Jordan Springs Residential
Development
Mixed Use Site
Stage 2 (Concept Design) Road
Safety Audit

Issue: B 10/03/14

Client: C.I.D Group

Reference: 14S1013000

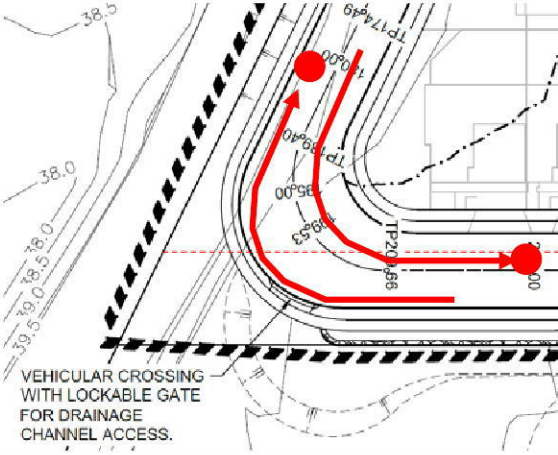
No.	Description	Figure	Classification	Likelihood	Severity	Risk Rating	Designer Comments
1	<p>The pedestrian kerb ramp located on the western side of the intersection of Road 1 with Jordan Springs Boulevard guides pedestrians to cross at a location where there is a narrow central median, with insufficient width to provide pedestrian protection. As a result, a pedestrian waiting in the median could be hit by a car.</p>		Pedestrian infrastructure	Occasional	Major	High	<p>The existing median is to be modified to include a right turn lane into the development.</p> <p>Existing pedestrian crossing facilities are to be demolished in this location.</p> <p>New pedestrian crossing facilities are to be constructed on the eastern side of the intersection (shown in DA documents, to be detailed in CC).</p>

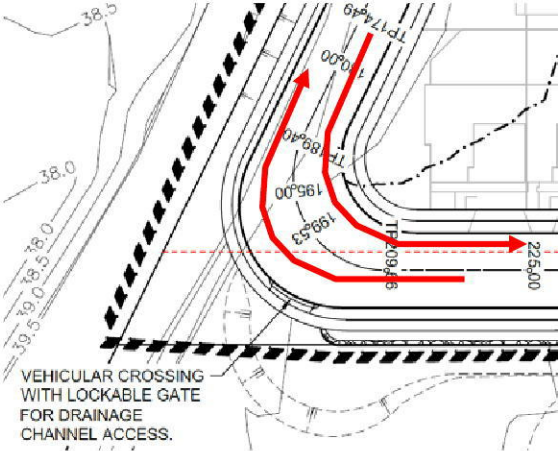
No.	Description	Figure	Classification	Likelihood	Severity	Risk Rating	Designer Comments
2	<p>A light pole and directional signage is located within the Jordan Springs Boulevard central median. These could obstruct pedestrian crossing movements as they appear to be located in the same location as future pedestrian crossing facilities.</p> <p>As a result, there could be insufficient pedestrian storage capacity within the central median, increasing the risk of a collision between a pedestrian and an approaching vehicle.</p>		Pedestrian infrastructure	Occasional	Major	High	<p>Existing light pole and signage location to be confirmed.</p> <p>Pedestrian crossing location to be coordinated and finalised during CC with the existing light pole and signage taken into consideration.</p>

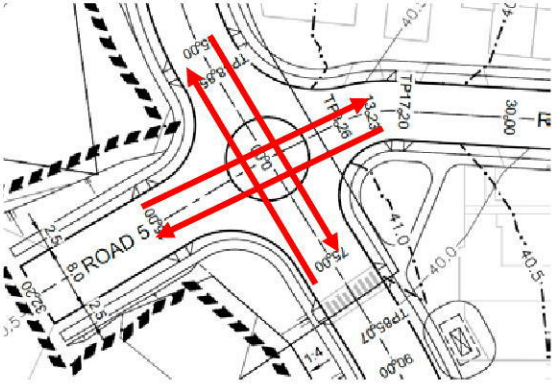
No.	Description	Figure	Classification	Likelihood	Severity	Risk Rating	Designer Comments
3	The sight lines around the bend in Road 1 could be restricted by property boundaries. As a result, a vehicle driving around this bend does not have sufficient reaction time should an obstruction be located on the other side of a bend. These vehicles could collide with another vehicle, pedestrian or object unexpectedly located within the road.		Road alignment and cross section	Occasional	Moderate	Medium	The development is a low speed environment and a high level of driver alertness can be expected. Signage and linemarking to be provided in CC including parking restrictions and warning signs.
4	Drivers may misjudge the safe cornering speed and approach the tight bend located in Road 1 too fast which may result in a loss of control type crash.		Road alignment and cross section	Highly probable	Major	High	The development is a low speed environment and a high level of driver alertness can be expected. There may be opportunity to include advisory type signage (to be assessed by Penrith City Council traffic committee at CC)

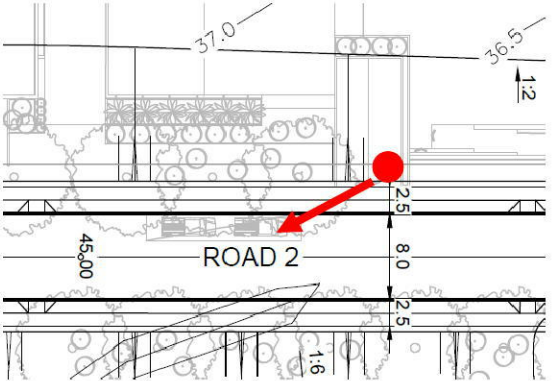
7	There is no protection provided along the retaining wall which runs along the south of the site and includes a sheer drop of approximately 1m. As a result, an errant vehicle may not be able to regain its position in the roadway and could roll over the retaining wall.		Roadside hazards	Occasional	Major	High	200mm high kerb to run along this frontage, DA typical section to be amended. Full clear zone and risk assessment to be conducted during CC.

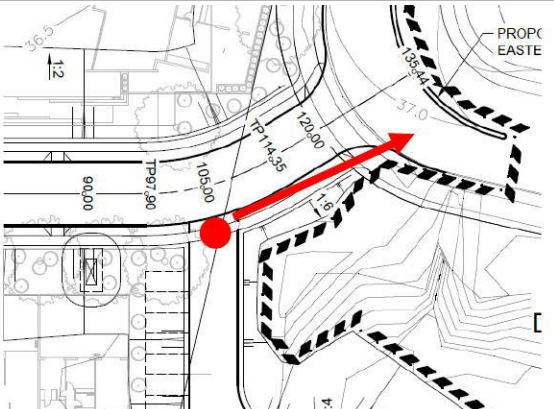
No.	Description	Figure	Classification	Likelihood	Severity	Risk Rating	Designer Comments
8	The location of the Loading Zone on the north side of Road No 2 may restrict the safe intersection sight distance of vehicles exiting the residential car park. A restricted safe intersection sight distance may result in side impact incidents.		Road alignment and cross section	Occasional	Moderate	Medium	The development is a low speed environment and a high level of driver awareness can be expected. The location of the loading zone could be reconsidered at detail design stage.
9	The access to the future car park on the south side of Road 2 is located approximately 25m – 30m from Lakeside Parade. Consequently, there may be insufficient safe intersection sight distance for vehicles exiting the proposed future car park. A restricted safe intersection sight distance may result in side impact incidents.		Road alignment and cross section	Occasional	Moderate	Medium	The development is a low speed environment and a high level of driver awareness can be expected. Vehicles turning into Road 2 from the collector road will be operating at a very low speed. No parking signage can be considered along Road 2 in the vicinity of the intersection to ensure that sight lines are not restricted.

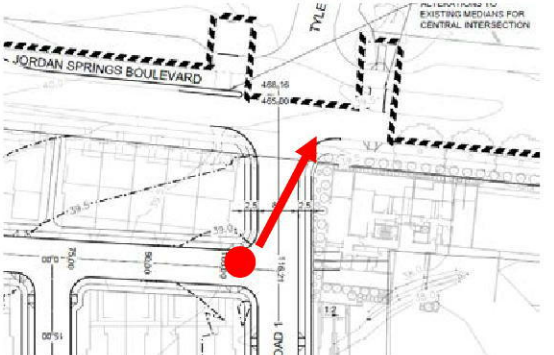
No.	Description	Figure	Classification	Likelihood	Severity	Risk Rating	Designer Comments
10	<p>The intersection of Road 3 and Road 1 is located in close proximity to the intersection of Jordan Springs Boulevard and Tyler Street. Consequently, there may be insufficient safe intersection sight distance for vehicles exiting Road 3. A restricted safe intersection sight distance may result in side impact incidents.</p>	 <p>The diagram is a technical site plan showing road layouts. It features 'JORDAN SPRINGS BOULEVARD' at the top and 'TYLER' street on the right. A vertical road labeled 'ROAD 1' runs through the center, and a horizontal road labeled 'ROAD 3' intersects it. A red circle is placed at the intersection of Road 1 and Road 3, with a red arrow pointing to it from the right. Dashed lines indicate sight lines or medians. Text at the top right reads 'PROPOSED FOR EXISTING MEDIANS FOR CENTRAL INTERSECTION'. Various dimensions and labels like '488.00', '485.00', '118.00', and '118.11' are scattered throughout the plan.</p>	Road alignment and cross section	Occasional	Moderate	Medium	<p>The development is a low speed environment and a high level of driver awareness can be expected.</p> <p>Vehicles turning into Road 1 from the collector road will be operating at a very low speed. No parking signage can be considered along Road 1 in the vicinity of the intersection to ensure that sight lines are not restricted.</p>

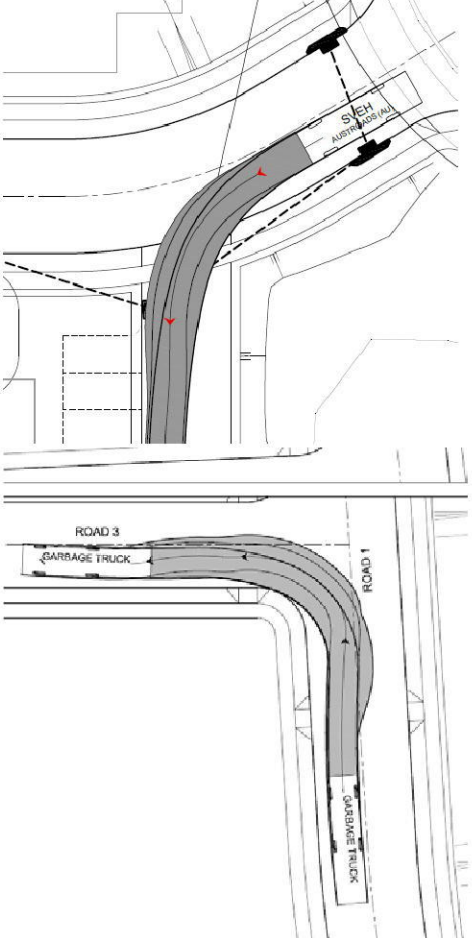
No.	Description	Figure	Classification	Likelihood	Severity	Risk Rating	Designer Comments
11	<p>The swept paths of a Garbage Truck illustrate a truck having to cross the centre line when undertaking a turning movement at an intersection which may lead to side impact incidents.</p>		Road alignment and cross section	Occasional	Minor	Low	<p>The development is a low speed environment and turning vehicles generally operate at a very low speed. Garbage trucks typically access a subdivision once a week which minimises the likelihood of an impact.</p>

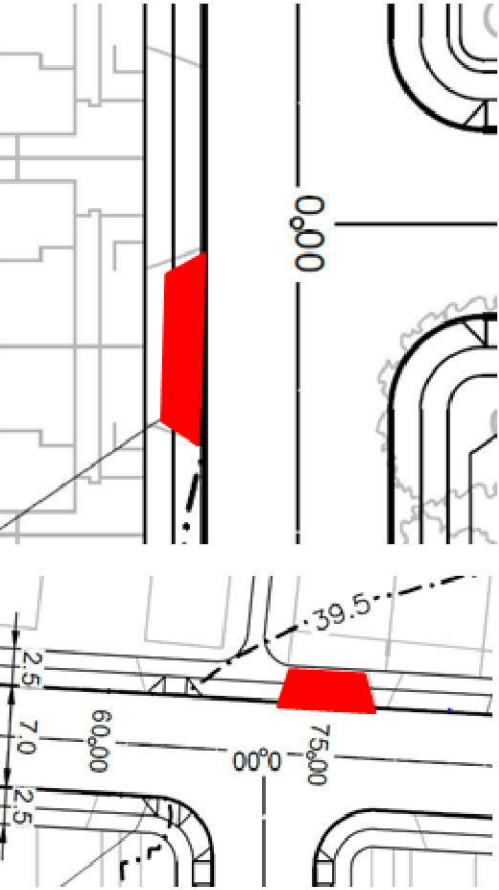
No.	Description	Figure	Classification	Likelihood	Severity	Risk Rating	Designer Comments
12	<p>Driveway accesses are located directly adjacent an intersection. An access driveway in this location creates uncertainty with regard to who has priority at the intersection.</p> <p>Motorist confusion at the intersection may increase the likelihood of a side impact collision.</p>		Access impacts	Improbable	Medium	Low	<p>This condition exists throughout Jordan Springs. Driveways in this location are generally compliant with AS2890.1, Fig 3.1.</p> <p>No action.</p>
